ANGUS SOUTH

Item #	Construction Details ANGUS SOUTH: LOT 155-8  Model Type & Elevation : 23-04 JASMINE ELEVATION A Purchasers Names : SANDRA LIPPETT		
		Date	Note
Included	<i>Rough-in for 3 Piece in basement</i>		Bonus Package
Included	<i>3 piece stainless steel kitchen appliances with white top loading washer and dryer</i>	-	Bonus Package
Included	<i>Chimney Hood Fan</i>		Bonus Package
Included	<i>Natural finish laminate flooring on main floor in non tiled areas as per plan</i>		Bonus Package
Included	<i>9' main floor ceilings, 8 ft ceilings on second and basement</i>		Bonus Package
Included	<i>Carpet Grade Stairs with Oak pickets</i>		Bonus Package
Included	<i>Glass shower in Master Ensuite as per plan</i>		Bonus Package
1/	BASEMENT WINDOWS - REAR ONLY - ENLARGE (2) BASEMENT WINDWS TO 30"X24"	6-Feb-17	COLOURS
2/	PLUMBING - WATER LINE TO FRIDGE	6-Feb-17	COLOURS
3/	KITCHEN CABINETS - UPGRADE NIK 1	6-Feb-17	COLOURS

JASMINE 2304

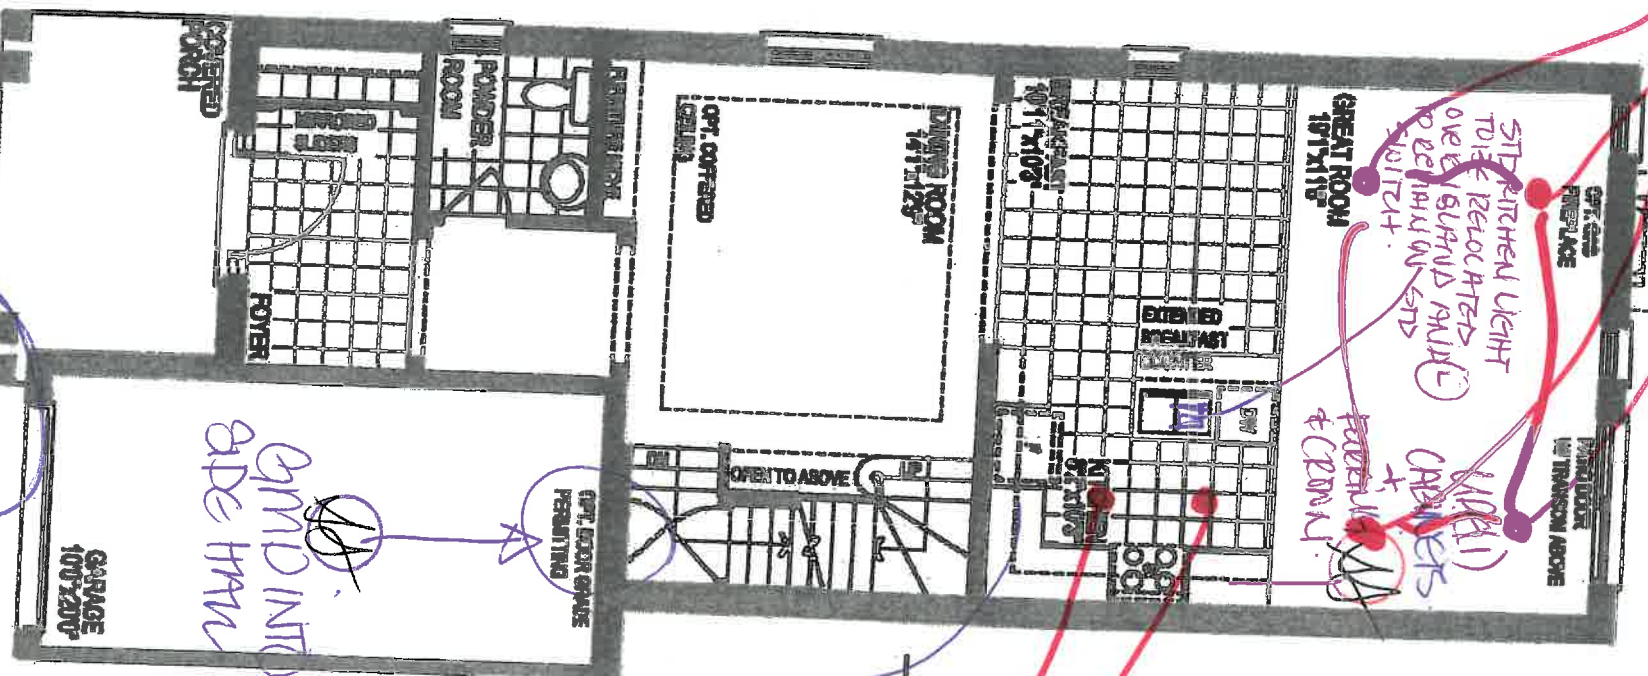
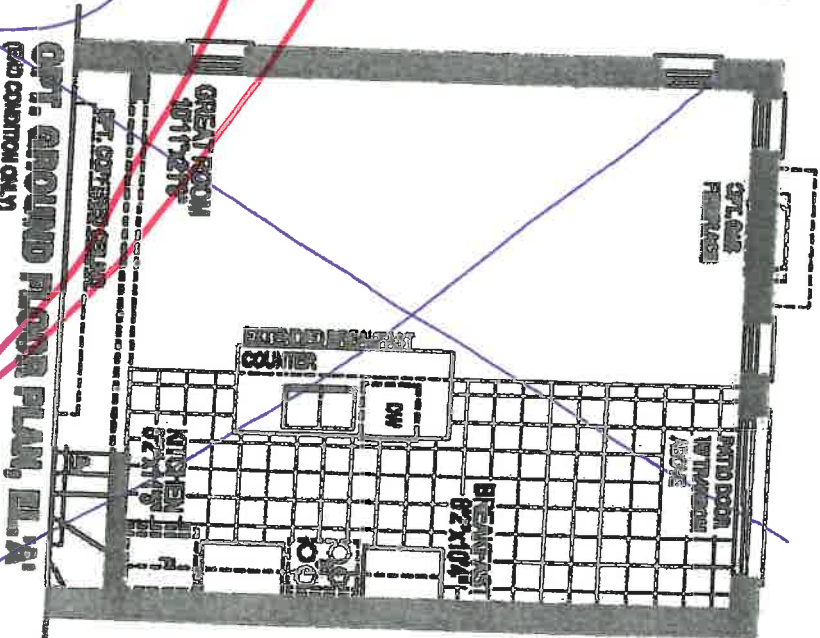
4 POTLIGHTS  
ON SEPARATE  
SWITCH

GRIND INTO  
SIDE TRAIL

water line  
for fridge. ON SEPARATE  
SWITCH.

**SECOND FLOOR PLAN, EL. 'A'**  
(END CONSTRUCTION ONLY)

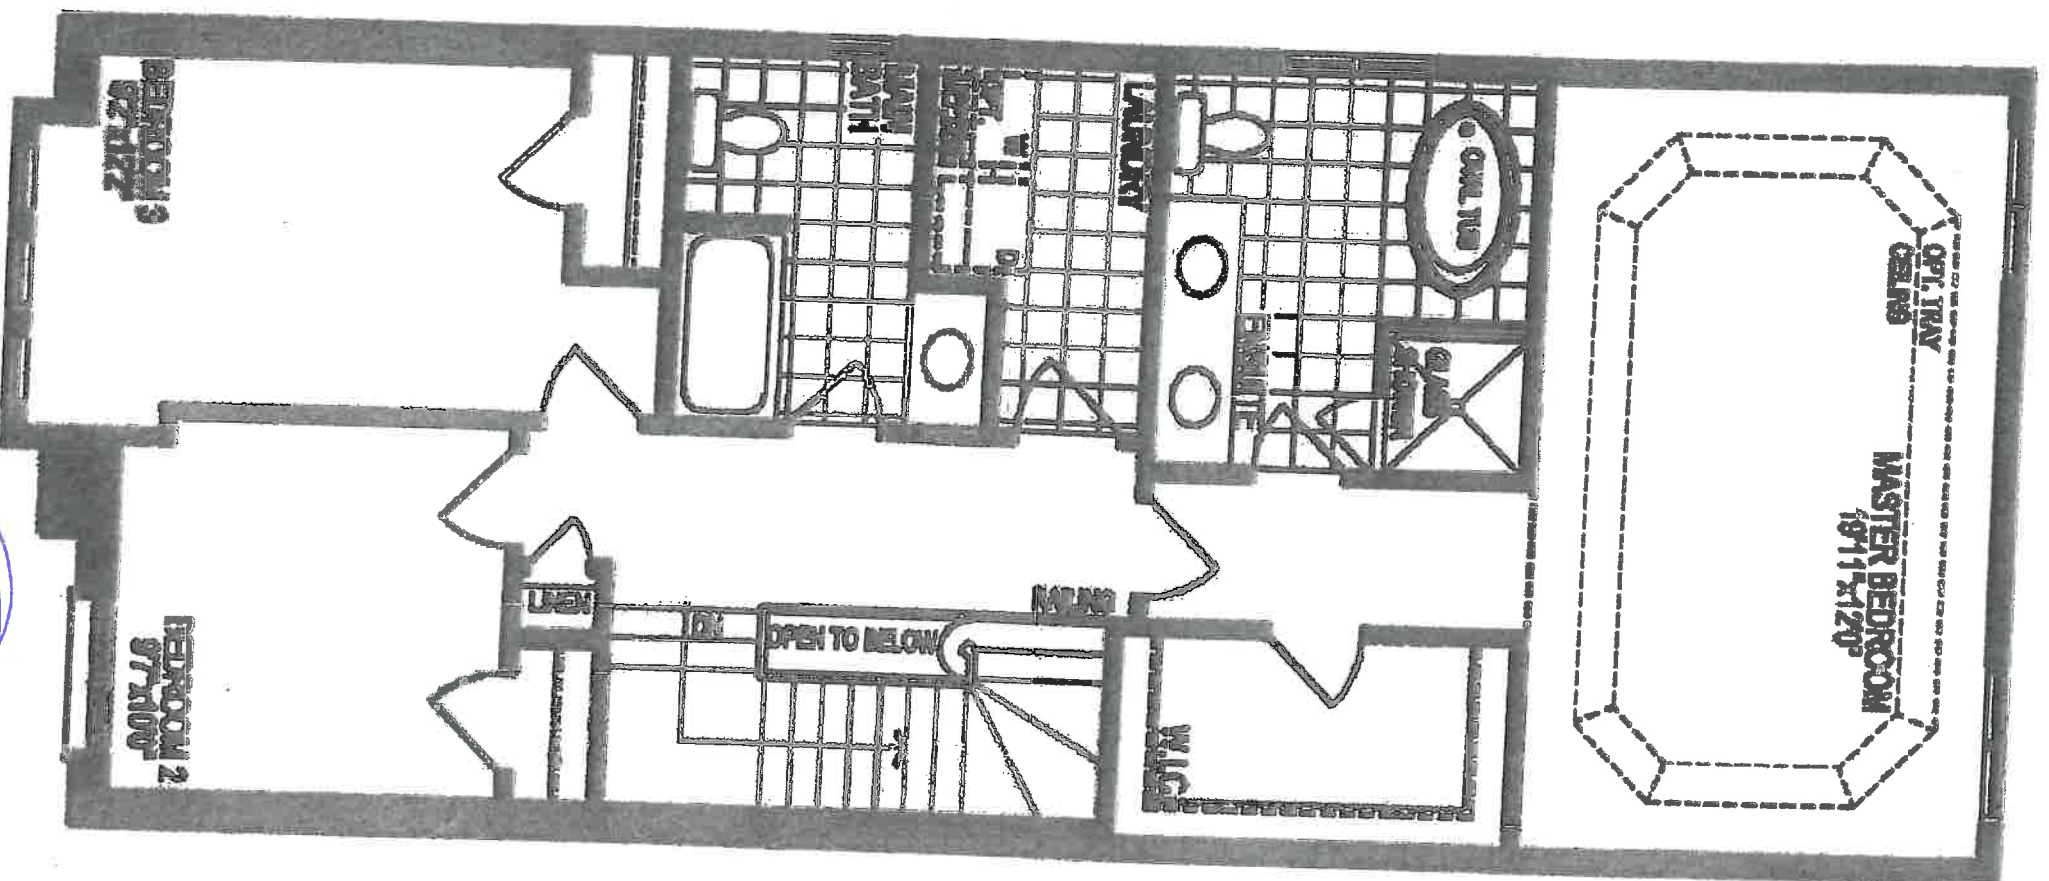
TWO POTLIGHTS

**BASEMENT PLAN, E.L. 1'**  
(AND CONDITION ONLY)

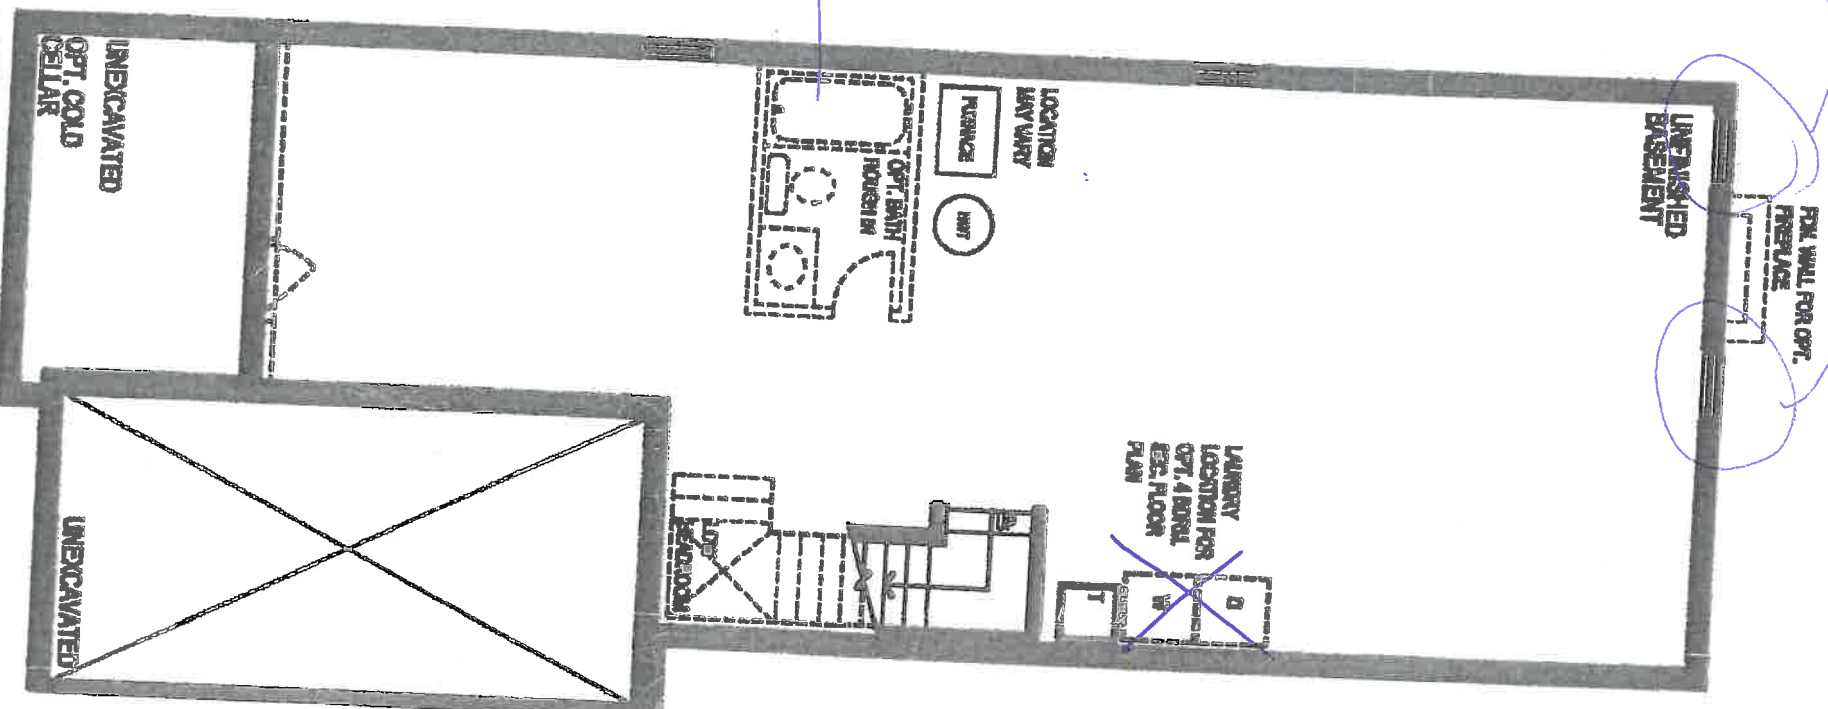
2 larger  
basement  
windows.  
Rear only  
30'x24'

3PC  
rough-in
